APPLICANT: Westinghouse Electric Corporation
FACILITY: AP600
SUBJECT: SUMMARY OF AP600 DESIGN REVIEW MEETING REGARDING THE PASSIVE CONTAINMENT COOLING SYSTEM (PCS) AND WGOTHIC COMPUTER CODE

Scaling Analysis for AP600 Containment Pressure
during Design Basis Accidents
WCAP-14845

Discussion Items, Additional Items, Open Items, RAI's

Figure 1 Buoyancy Calculation for the AP600 PCS Air Flow Path Comparing Distributed and Thermal Center Approaches

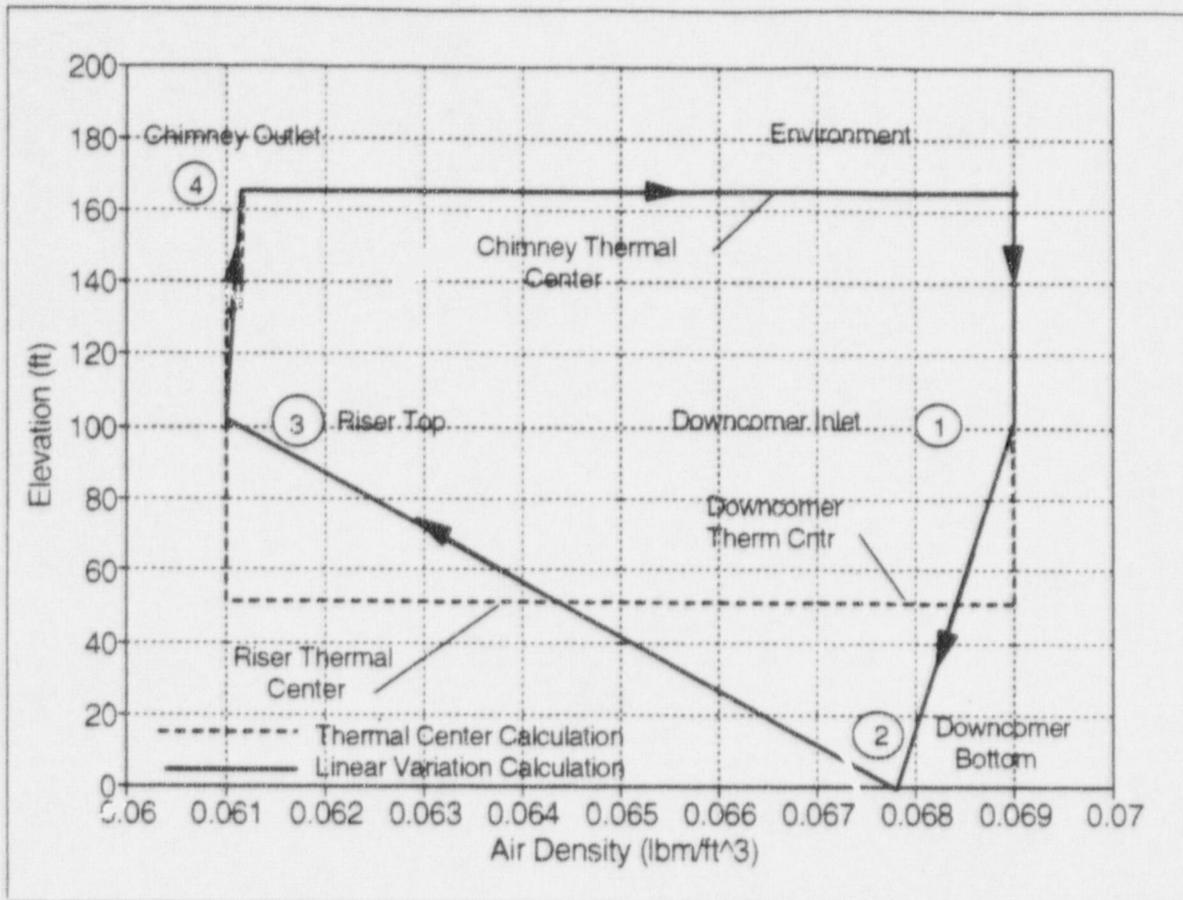
- 28. The buoyancy term (equation 102) is stated to be in terms of "thermal center"

differences. It is difficult to tell from Figure 8, just how H1, H2, H3 and H4 are defined. However, the densities, ρ_{dc} , ρ_{ri} , ρ_{ch} and ρ_{nv} are calculated based upon exit temperatures. If H2 - H3 is the riser height, then using a density based upon exit temperature will overestimate the buoyancy force by about a factor of about 2, since the average density should be used. Please explain how your approach accounts for the variation in density along each segment of the flowpath.

28. Figure 9-1 of WCAP-14845 clarifies the location of thermal centers. The discussion in Section 9.3.1 and Figure 9-2 show how the thermal centers are used with the density to calculate the buoyancy. The example calculation in WCAP-14845 is repeated below.

Figure 1 shows an example of a simplified PCS buoyancy calculation using density values calculated for the beginning of the long term time phase of the LOCA. The density variations over each leg of the air flow path are assumed to be linear. The net buoyancy is represented by the enclosed area. The buoyancy calculated using the thermal center approach is shown for comparison. For this case both the distributed density and thermal center approaches give the same result. Note that for this assumed case, the net buoyancy is not affected by the amount of heat transferred from the riser to the downcomer. (Moving point 2 along the horizontal axis does not change the area within triangle 1-2-3). However, moving point 2 does change the relative ratio of negative downcomer buoyancy to positive riser buoyancy. Moving the thermal centers of the downcomer and riser up to the 84 ft elevation, as was done for the AP600 scaling calculation, significantly reduces the net buoyancy.
